# UNITED STATES PATENT AND TRADEMARK OFFICE

APPLICATION NO.	FILING DATE	FIRST NAMED INVENTOR	ATTORNEY DOCKET NO.	CONFIRMATION NO.
10/656,797	09/04/2003	Niel F. Starksen	578-492001500	7101
25226 7590 09/17/2009 MORRISON & FOERSTER LLP 755 PAGE MILL RD PALO ALTO, CA 94304-1018				
EXAMINER				
DOWE, KATHERINE MARIE				
ART UNIT		PAPER NUMBER		
3734				
MAIL DATE		DELIVERY MODE		
09/17/2009		PAPER

### Office Action Summary

## **DETAILED ACTION**

*Applicant's annotated drawings presented on pages 11-12 of Remarks filed May 11, 2009*

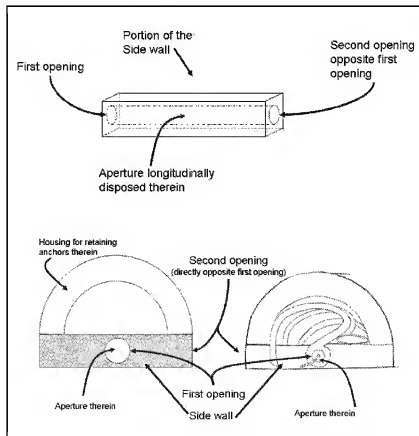
In the remarks filed May 11, 2009, Applicant argues the limitation, "wherein the side wall has at least one aperture disposed longitudinally therein the aperture having a first opening and a second opening" should be interpreted such that the "aperture" is equivalent to a lumen within the side wall of the housing, separate from the main lumen of the housing. And the "first and second openings" should be interpreted as proximal and distal openings of the lumen. See Applicant's sketch/annotated drawings provided in the remarks filed May 11, 2009 copied below:

The specification does not recite any type of aperture within the side wall of the device, separate from the main lumen of the housing. Furthermore, the drawings do not clearly depict such an aperture. The specification additionally does not recite any structural relationship between the mandrel and the housing, other than that the mandrel couples the hooks, or anchors, to the device. The drawings appear to show the mandrel is within the main lumen of the housing device, not within a separate lumen within the side wall of the housing. The Examiner additionally notes neither the specification nor the drawings depict or describe the proximal end of the device, and thus there is no support for a second opening opposite the first opening, whether or not the Applicant is referring to the lumen within the side wall of the device or if the Applicant is referring to the main lumen of the housing that contains the anchors and the tether.

*Examiner's annotated version of Figure 8 of instant application*

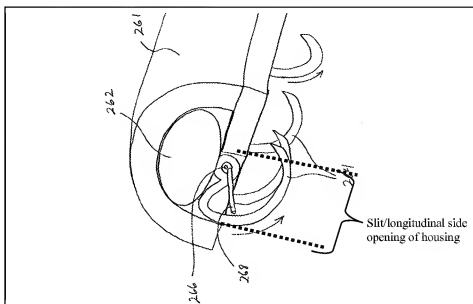
As shown above, Applicant argues the "aperture" should be interpreted as a lumen within the side wall of the housing, separate from the main lumen of the housing. It is unclear how the device will operate as disclosed if the mandrel may be housed within its own aperture within the sidewall of the housing. The ends of the hooks that should be coupled to the mandrel are not capable of encircling the mandrel if the mandrel is within its own aperture separate from the main lumen of the housing. The only way the hooks may be coupled to the mandrel as disclosed is if the hooks and mandrel are contained within the same aperture. However, if the hooks are contained within the lumen of the side wall, the hooks are not capable of pivoting about the mandrel to engage tissue. Figures 5A-5D and 8 clearly show the anchors, tether, and mandrel are housed within a main lumen of the housing, wherein the housing comprises a slit or side opening for the anchors to be pivoted out through and engage tissue. See annotated portion Figure 8 below:

No such aperture appears to be disclosed. The specification does not recite the term "aperture" or "opening", much less a "first opening" and a "second opening". The drawings do not clearly show the claimed aperture or openings either. Furthermore, if

the mandrel is contained within an aperture, or lumen, of the side wall separate from the main lumen of the housing, it is unclear how the anchors may be coupled to the mandrel and how the anchors may pivot about the mandrel to engage tissue.

8. The drawings are objected to under 37 CFR 1.83(a). The drawings must show every feature of the invention specified in the claims. Therefore, the aperture disposed longitudinally within the side wall of the housing having first and second openings and a mandrel retained therein must be shown or the feature(s) canceled from the claim(s). No new matter should be entered.
